Access Compliance Report

Public Rights-of-Way

(Curb Ramps)

Intersection ID: 2731	Main Street: TANAGER_LN	Cross Street: VIREO_CT	Location: NW
ADA ID: 62749CE7FDCC	Ramp Type: Perp	Initial Pass/Fail: Fail	Overall Compliance: No
Severity Score: 22.5			
Codes/Mitigation Info/Possible Solution		Field Measurements/Component Compliance

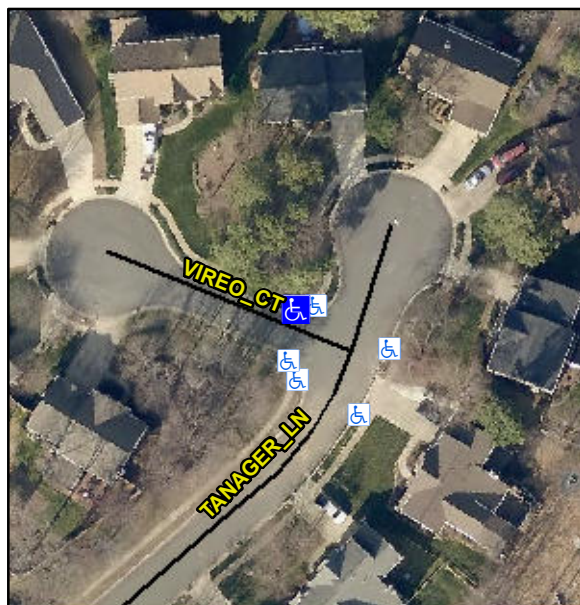
R304.5.1, R304.2.2, R304.5.3

Compliance	Description	Data	Compliance	Description	Data
N/A	Ramp Length (in)	49.0	No	Ramp Slope (%)	8.4
No	Ramp Width (in)	44.0	No	Ramp XSlope (%)	3.2
N/A	Flare Type LT	N/A	N/A	Flare Type RT	N/A
N/A	Flare Slope LT (%)	N/A	N/A	Flare Slope RT (%)	N/A
N/A	Flare Traversable LT?	N/A	N/A	Flare Traversable RT?	N/A
N/A	Landing Length (in)	N/A	N/A	DWS Provided?	N/A
N/A	Landing Width (in)	N/A	N/A	DWS Contrast?	N/A
N/A	Landing Slope (%)	N/A	N/A	DWS Length (in)	N/A
N/A	Landing X Slope (%)	N/A	N/A	DWS Full Width?	N/A
N/A	Landing Curb? (Y/N)	N/A	N/A	DWS Offset (in)	N/A
N/A	Shared Landing?	N/A			
N/A	Gutter Ponding?	N/A	N/A	Gutter Slope (%)	N/A
N/A	Gutter Lip Ht (in)	1.0	N/A	Gutter X Slope (%)	N/A
N/A	Painted X Walk1?	No	N/A	Painted X Walk2?	N/A
	X Walk 1 Direction	To SW		X Walk 2 Direction	N/A
N/A	X Walk 1 Width (in)	N/A	N/A	X Walk 2 Width (in)	N/A
	X Walk 1 Slope (%)	4.6		X Walk 2 Slope (%)	N/A
	X Walk 1 X Slope (%)	5.6		X Walk 2 X Slope (%)	N/A

Remove & Replace Entire Ramp.
